APPLICATION FOR PERMIT TO DRILL OR REENTER

| 3a. Address 550 W. Texas, Suite 1300 Midland TX 79701 | | 8 Lease Name and Well No. (302499) GISSLER FEDERAL #13 |

SUNDRY NOTICES AND REPORTS ON WELLS

| TYPE OF SUBMISSION | TYPE OF ACTION | | | |
|--|---|---|--|--|
| <input type="checkbox"/> Final Abandonment Notice | <input type="checkbox"/> Casing Repair | <input type="checkbox"/> New Construction | <input type="checkbox"/> Recomplete | <input checked="" type="checkbox"/> Other <u>Change location</u> |

WELL LOCATION AND ACREAGE DEDICATION PLAT

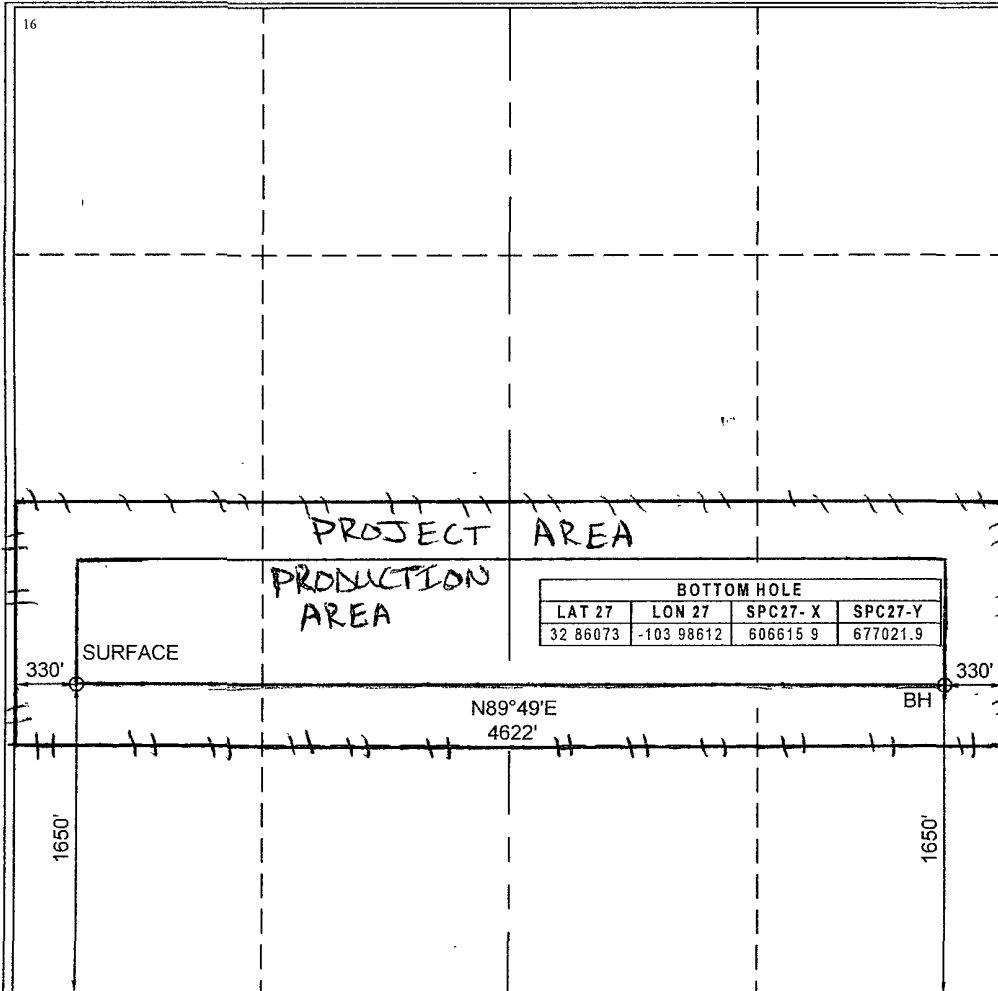
COG permitted this well at this location:
1650 FSL & 330 FWL SEC. 5, T17S, R30E, UNIT L

COG respectfully requests permission to move this location to:
SHL: 1650 FSL & 330 FWL SEC. 5, T17S, R30E, UNIT L
BHL: 1650 FSL & 330 FEL SEC. 5, T17S, R30E, UNIT I

This move is requested to drill this well as a horizontal.

A revised C-102, Directional Plan and Drilling Plan are attached for your review.
